An
Coimisiún
Pleanála

Specialist Report to Inspector

R322363_App1

Installation of additional underground effluent storage and construction of a new plant and storage building together with all associated site works.

Figure 3.2 Concentration of Ammonia (mg/L NH₄-N) in GW3 over 177 days in 2024

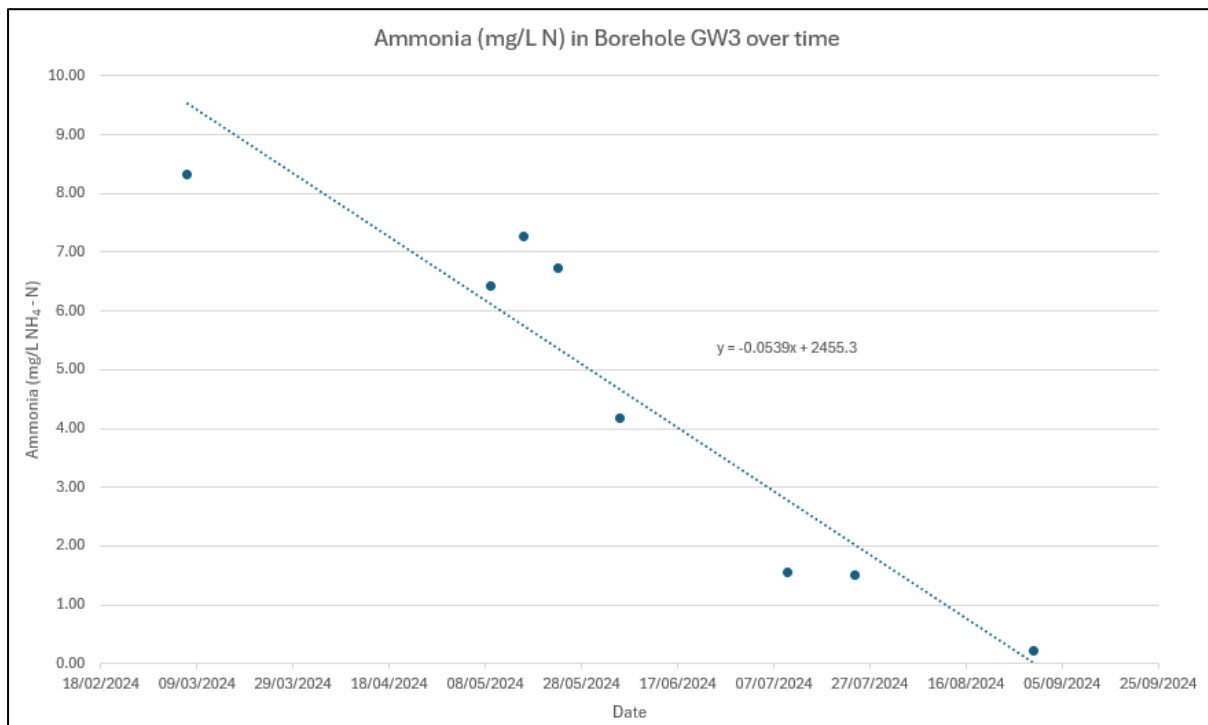
I carried out an investigation of this reduction in ammonia levels in GW3 to assess when the levels would reduce to background concentrations. The monitoring data for GW3 ammonia results for this period was plotted against time and a trendline calculated (see figure 6.2 below). Using the equation of this line, it was estimated that the concentration of ammonia within GW3 could return to background levels (assumed to be 0.032 mg/L NH₄-N) by September 20th, 2024, assuming the same

rate of depletion/attenuation within the borehole. The assumption that the attenuation/depletion rate remains constant is dependent on several factors such as the performance of the wwtp, removal rates of raw wastewater for treatment off-site, rainfall amounts, groundwater flow rates etc. This timeframe is not definitive but can be taken as indicative based on the data provided in the report.

Figure 3.5 Annual average and 95%ile readings for Ammonia concentration at Ballysmuttan Bridge (2017 – 2024)

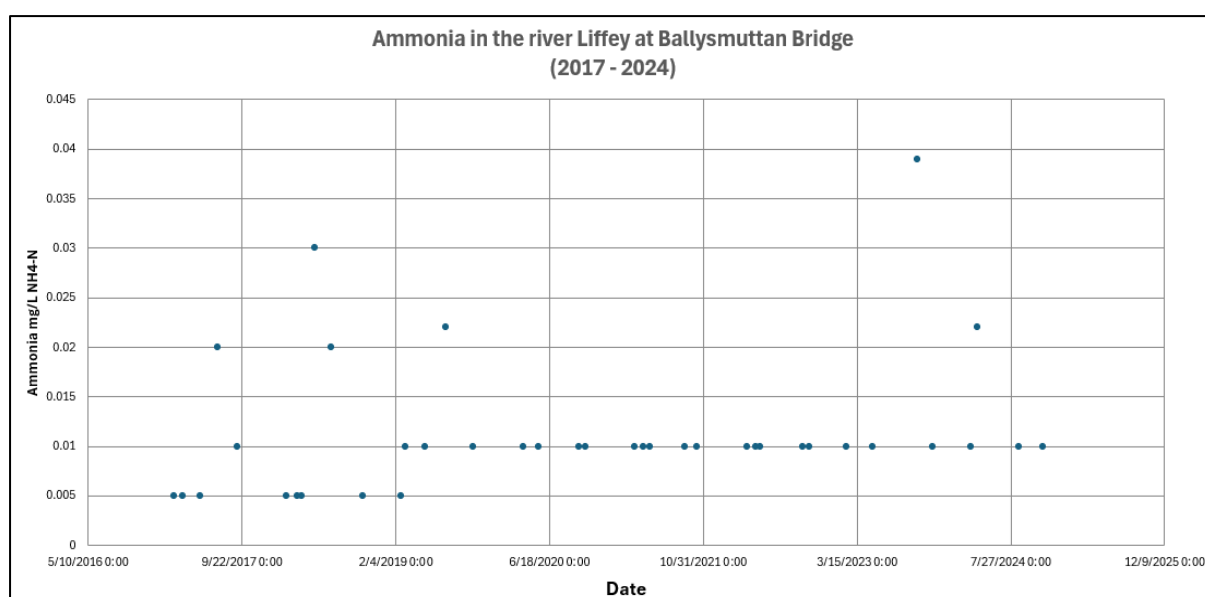
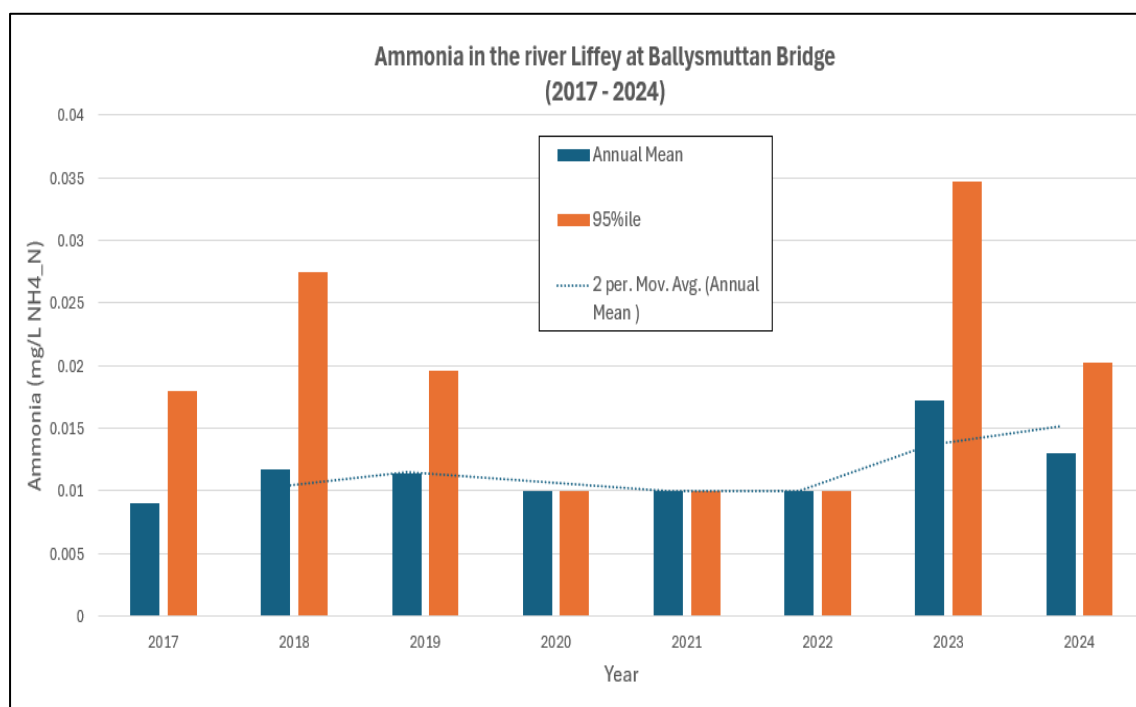
The ammonia data for Ballysmuttan Bridge was assessed and is presented in figures 3.4 and 3.5 below. The data for 2017 to 2024 shows that ammonia levels at Ballysmuttan Bridge have often been below the limit of detection (0.02 mg/l N) for the analysis of ammonia indicating a low-ammonia environment is present in the river Liffey at this location. Occasional readings > 0.02mg/L N have been noted since 2017 and one reading >0.035mg/L N recorded in September 2023.

3.6.3. When the annual averages and 95%ile values were calculated it suggested that these values have increased in 2023 and 2024 compared to the previous 5 years. However, most samples taken over these 2 years were below the limit of detection, and the inclusion of one higher sample result can have a significant impact on the average values when sampling takes place 4 or 5 times per year. In the 2023 and

2024 sampling period, six out of the eight samples taken returned values for ammonia below the limit of detection.

- 3.6.4. These annual averages and 95%ile values remain indicative of a 'High Status' river waterbody being less than the Surface Water Regulations threshold values of 0.040 and 0.090 respectively for Total Ammonia. Having regard to the water quality data, there is no evidence that the malfunctioning wastewater treatment system at Kippure has had an impact on Ammonia concentrations in the river Liffey.
- 3.6.5. I also assessed the water quality data for the Ballylow Brook_010 and Ballydonnell Brook_010 waterbodies for the same period (2017 -2024) and noted no significant increases in ammonia values in both waterbodies between 2022 and 2024 which mirrors that noted downstream in the river Liffey at Ballysmuttan Bridge. These 2 waterbodies act as 'control' sites in this scenario as they cannot be impacted by any activity at the Kippure site.

Figure 3.7 Annual average and 95%ile readings for TON concentration at Ballysmuttan Bridge (2017 – 2024)

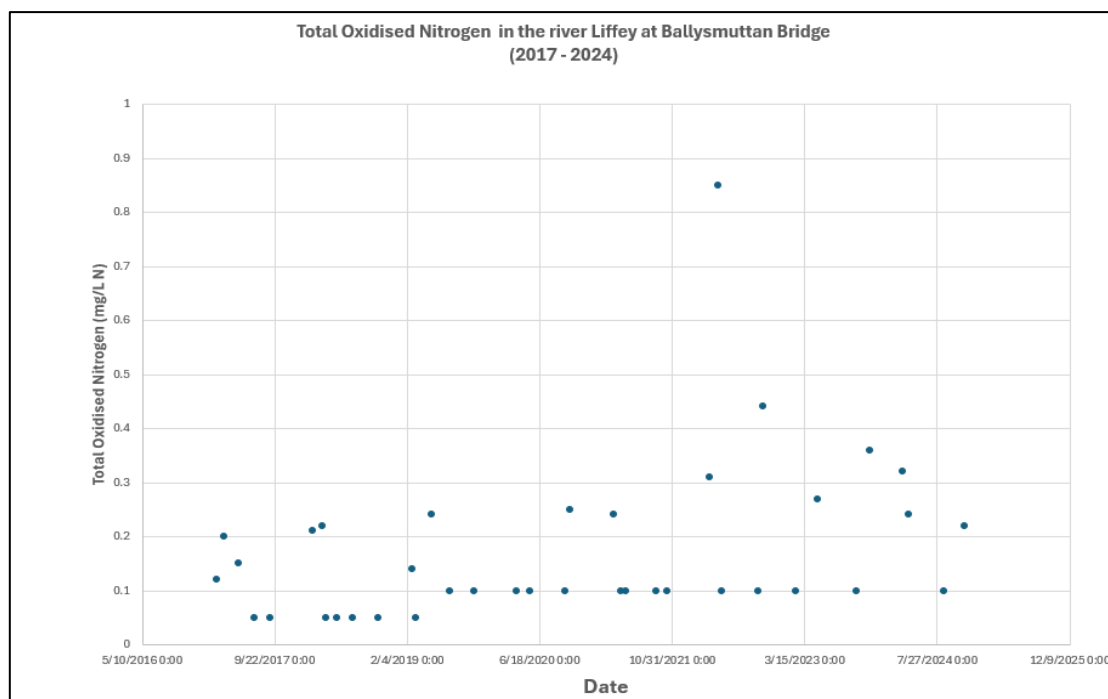
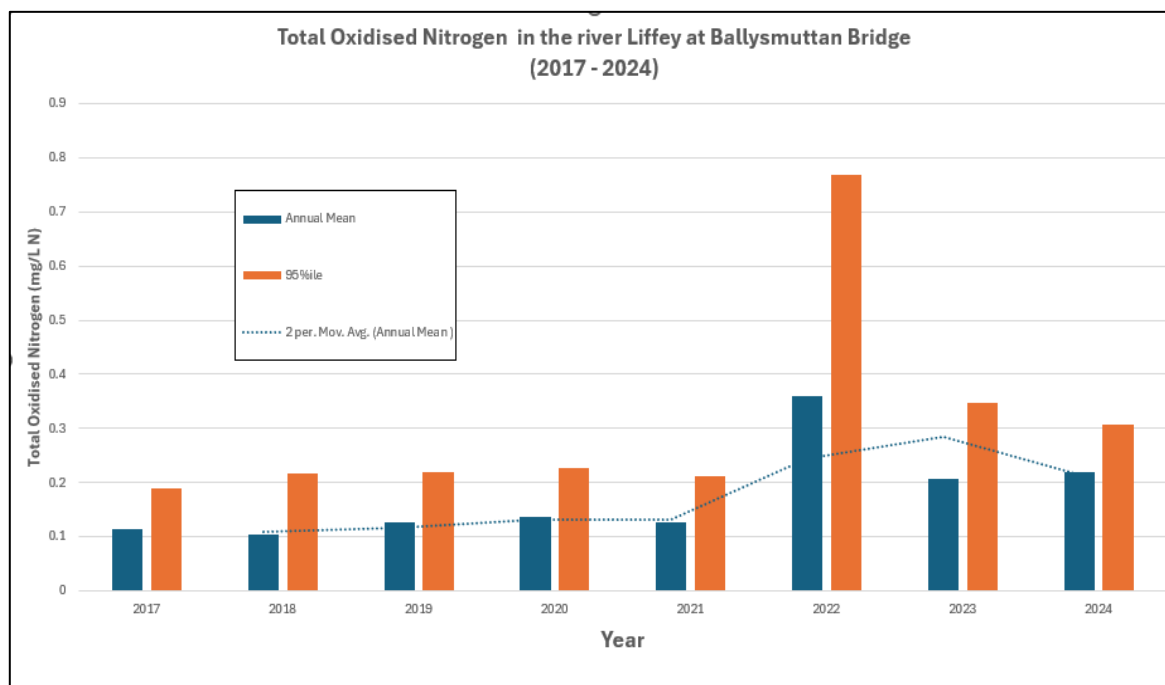
- 3.6.6. The Total Oxidised Nitrogen (TON) data for the river Liffey at Ballysmuttan Bridge was assessed and is presented in figures 3.6 and 3.7 below. The data for 2017 to 2024 showed that TON results at Ballysmuttan Bridge have often been below the limit of detection for the analysis of TON indicating a low-oxidised nitrogen environment is present in the river Liffey at this location. Occasional readings > 0.02mg/L N have been noted since 2017 with one reading of 0.85mg/L N in 2022. The data presented in Figure 6.6 indicates that the levels of TON may have increased at this location since 2022.

When the TON annual averages were calculated along with the 95%ile values for the same periods, it confirms that these values have increased in 2022, 2023 and 2024 compared to the previous 5 years.

The annual average TON values noted in the river Liffey at Ballysmuttan Bridge in the period in question although increased, were below this value by a factor of five or more.

Figure 3.9 Annual average and 95%ile readings for Ortho-phosphate concentration at Ballysmuttan Bridge (2017 – 2024)

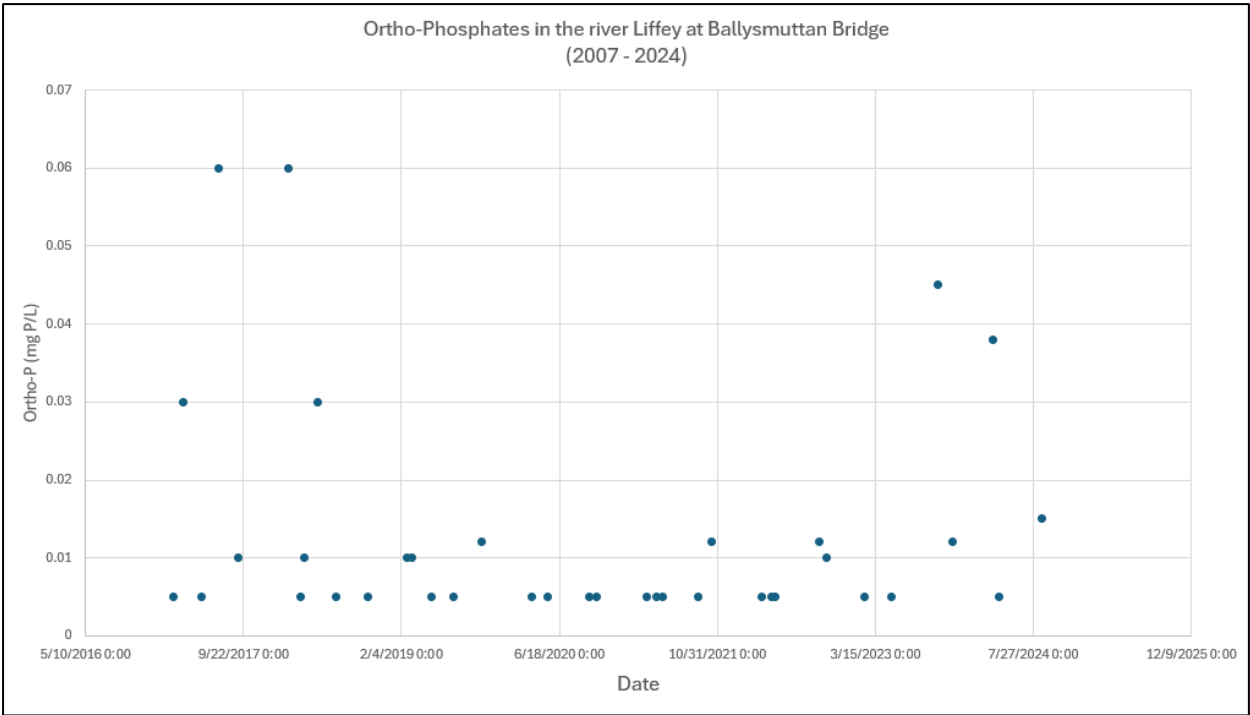
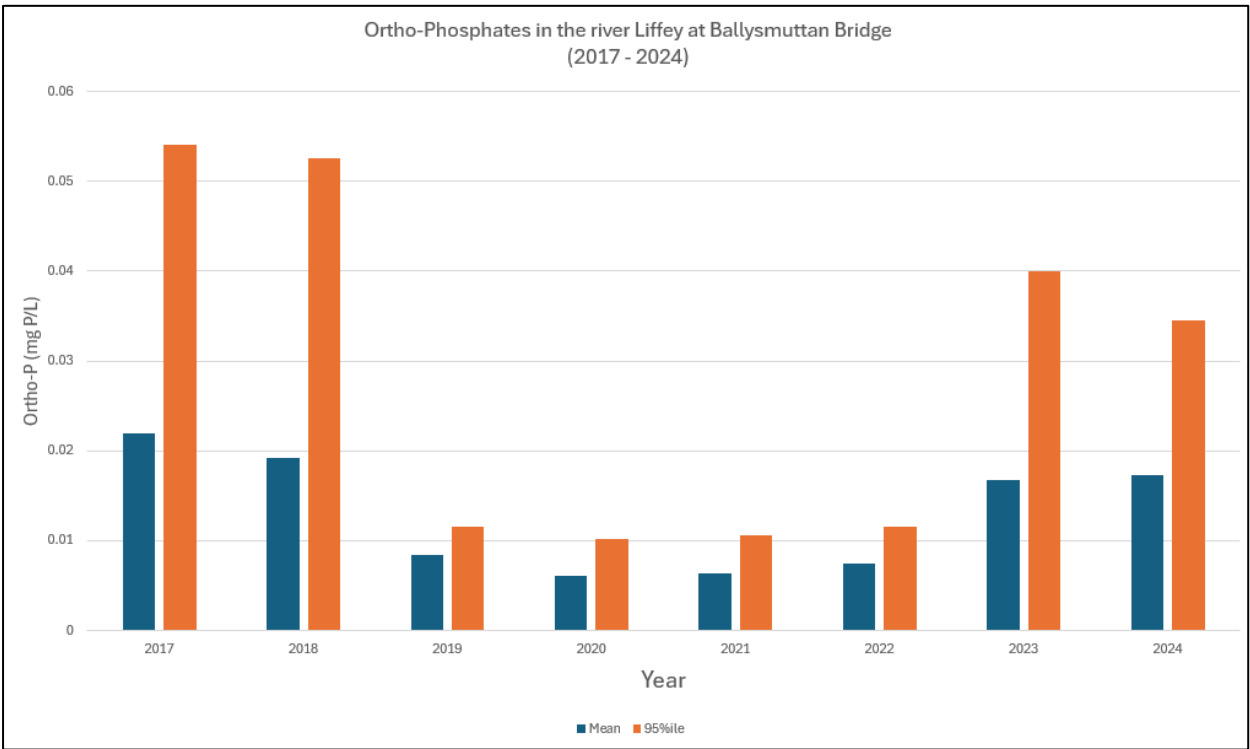
- 3.6.9. The Ortho-phosphate data for Ballysmuttan Bridge was assessed and is presented in figures 3.8 and 3.9 below. The data for 2017 to 2024 showed that orthophosphate results for the river Liffey at Ballysmuttan Bridge have often been below the limit of detection (0.01 mg/l P) indicating a low-phosphate environment is present at this location. Occasional readings > 0.02mg/L P have been noted since 2017 and two reading >0.036mg/L N recorded in recent years.

When the annual averages were calculated along with 95%ile values for the same periods, it suggests that the annual average values have increased in 2023 and 2024 compared to the previous 4 years. However, five of the eight samples taken over these 2 years were either below the limit of detection or within 20% of the limit of detection.

The annual averages and 95%ile values are indicative of a 'High Status' river waterbody being less than the Surface Water Regulations threshold values of ≤ 0.025 mgP/l and ≤ 0.040 mgP/l respectively for Molybdate Reactive Phosphorous (Orthophosphate).
